**RE: KINGS PARK WASTE METAL RECYCLING FACILITY (SSD 5041)-
RESPONSE TO STATE AGENCY AND COMMUNITY
SUBMISSIONS**

RESPONSE TO SUBMISSIONS

**RE: KINGS PARK WASTE METAL RECYCLING FACILITY
23-43 TATTERSALL ROAD AND 45 TATTERSALL ROAD, KINGS PARK
RESPONSE TO RMS CORRESPONDENCE**

Figure 1: AM Peak Hour Traffic Volumes – Existing (+Additional)

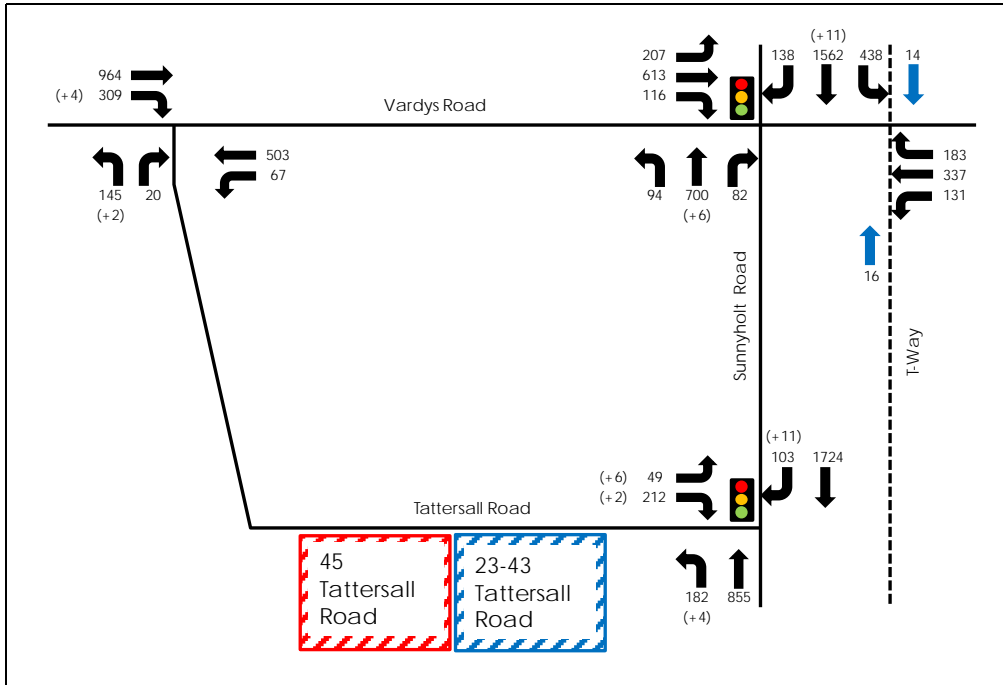
1. It is noted that the details of the intersection modelling has not been provided to Roads and Maritime for review. The applicant needs to provide electronic copies of the SIDRA models to Roads and Maritime for review.
2. It seems the intersections of Sunnyholt Road/Vardys Road and Sunnyholt Road/Tattersall Road have been modelled in isolation. These two intersections are too close to each other and one intersection would impact on the performance of the other intersection. Therefore, these two intersections need to be modelled as coordinated intersections.
3. The assumptions for the traffic distribution need to be clearly stated and justified.

There was a minor error in the GTA report when the traffic was distributed onto the road network during the AM peak hour. The updated traffic distributions for the AM and PM (unchanged) peaks hours are provided below.
